# **EFNA Steering Committee**

## **Meeting Summary**

### **Lacy Road**

### **Fitchburg Community Center to S. Syene Road**

FINISHED TYPICAL SECTION  
LACY ROAD

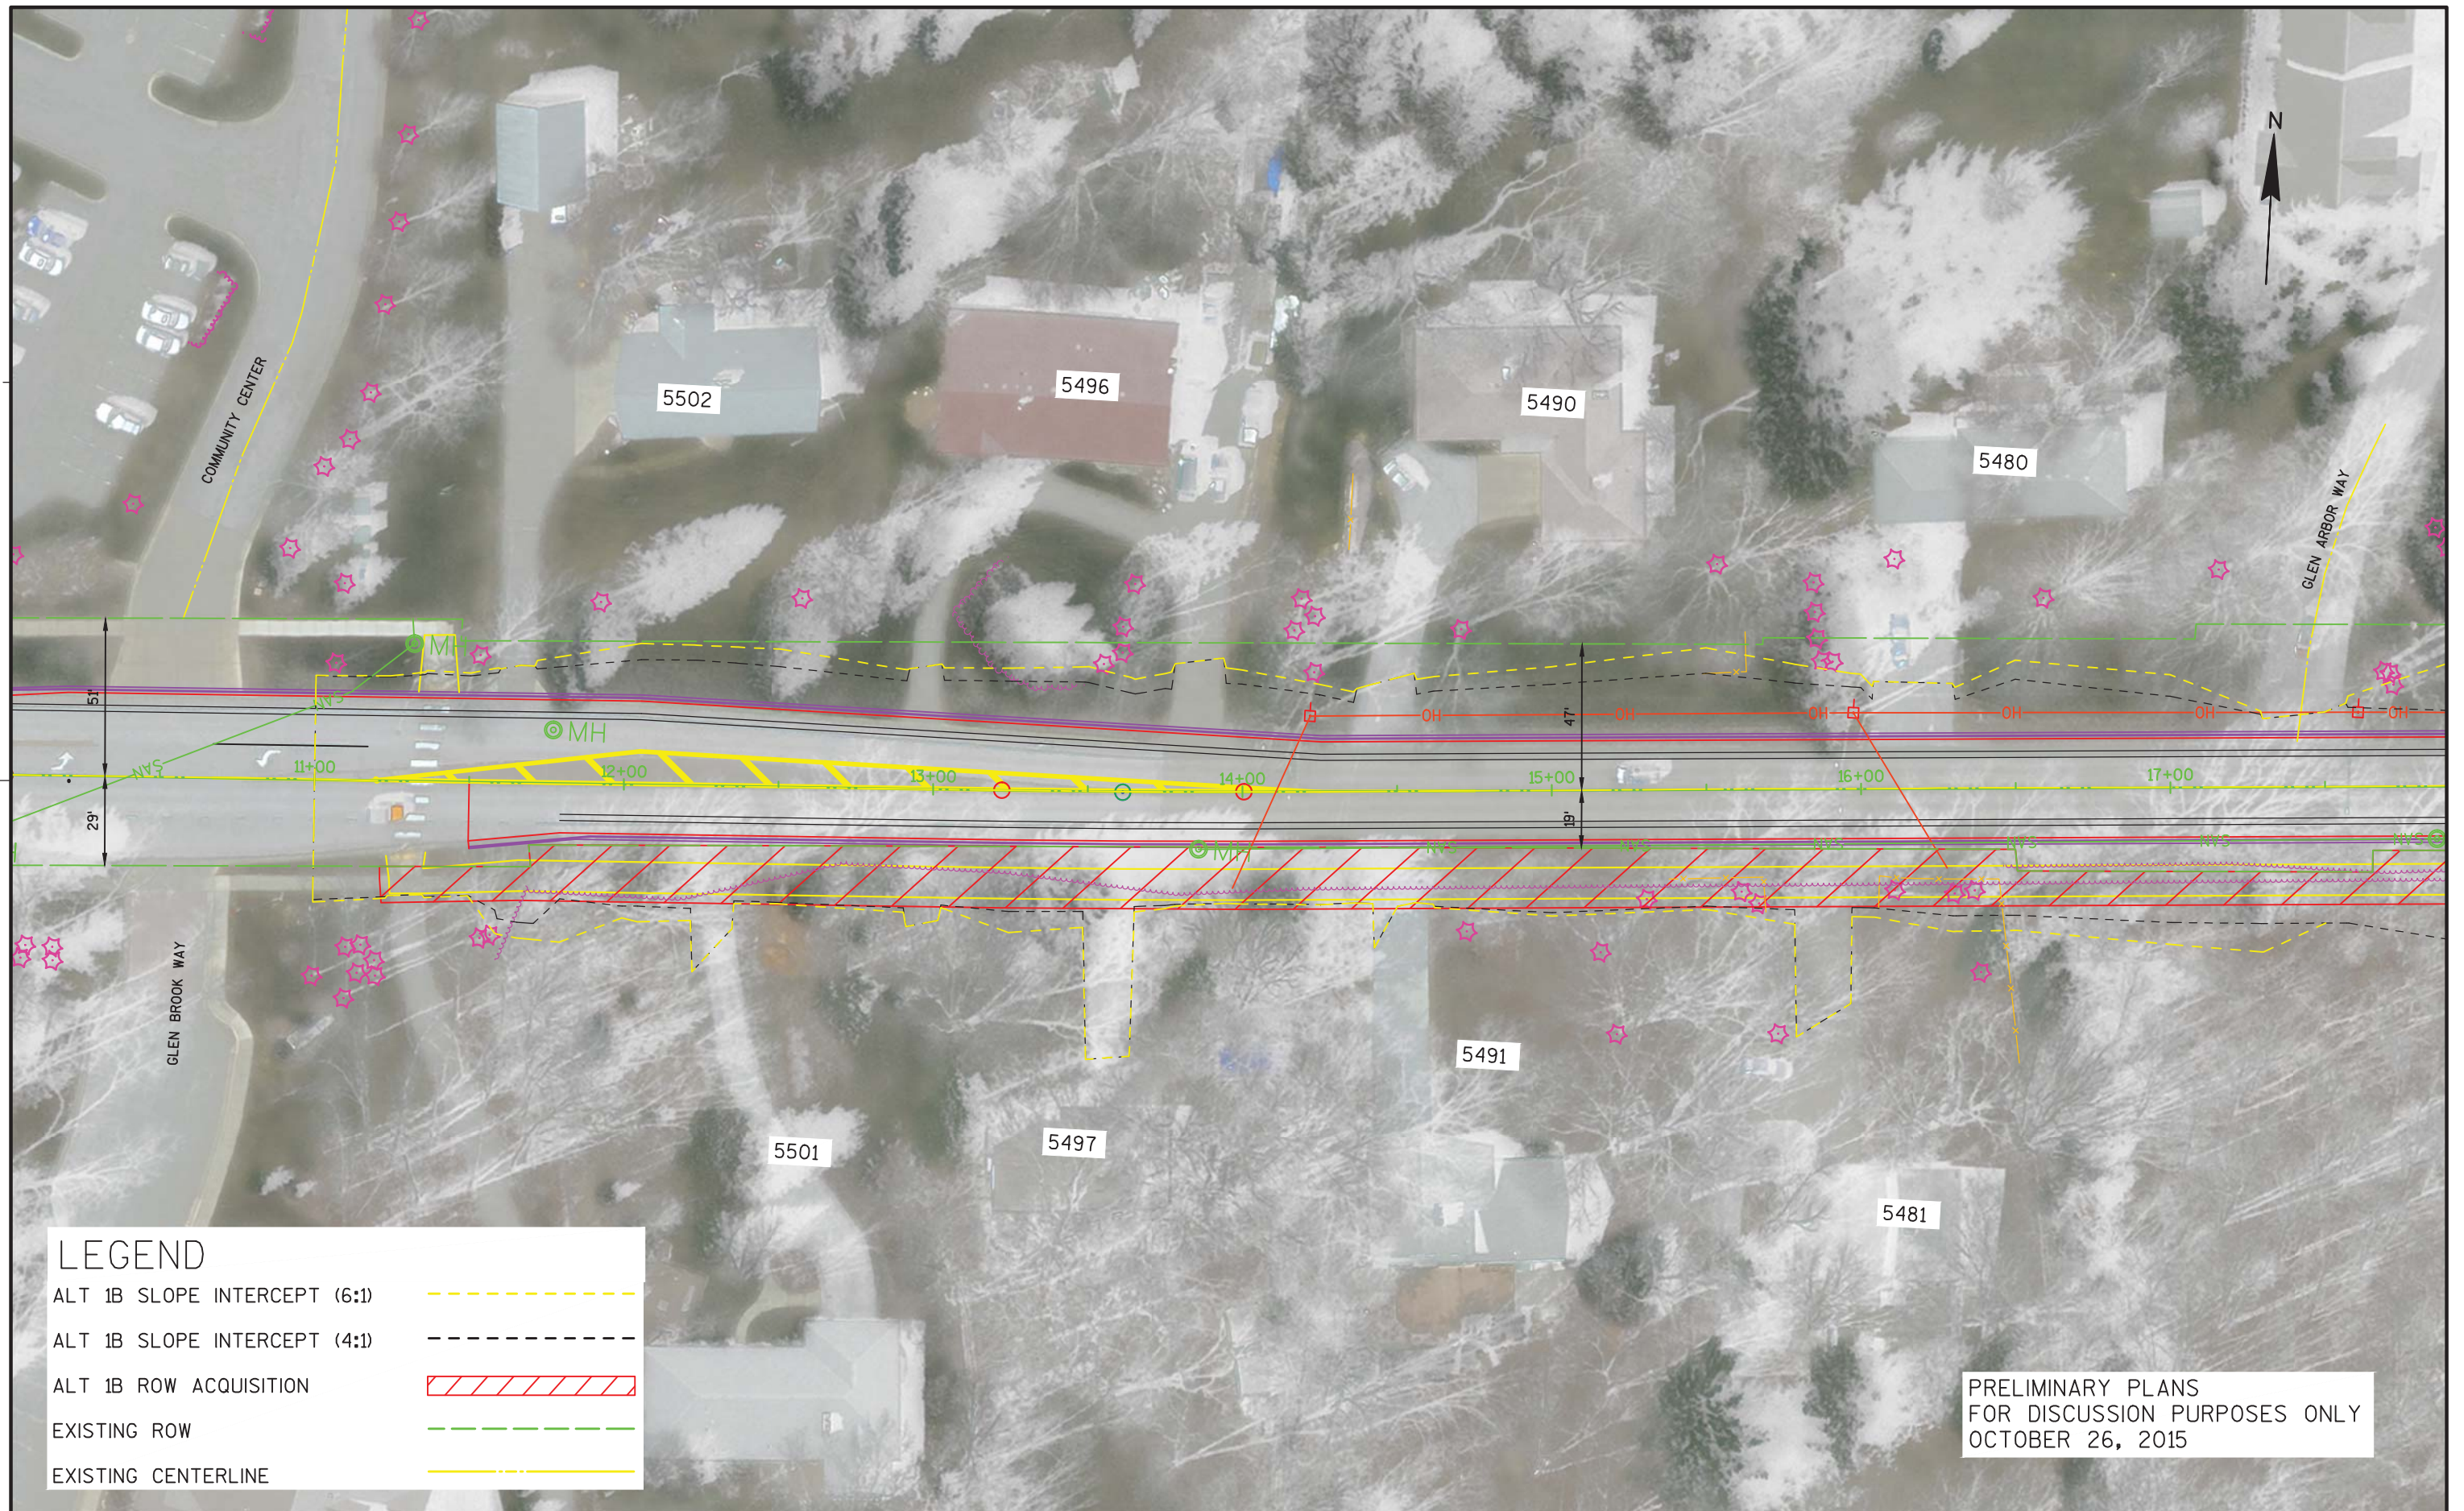
5. Preliminary design plans – Troy discussed the approved typical section the exhibit which depicts the approved section (attached). A question was raised about the terrace width. Ahna commented that the terrace width was intentionally not included in the typical section approval. She commented that it makes sense to allow for flexibility in the terrace width to adjust to the conditions. She stated that the standard width would be 7', but could get narrower at pinch points or wider where there is adequate right-of-way to increase the width of the terrace.
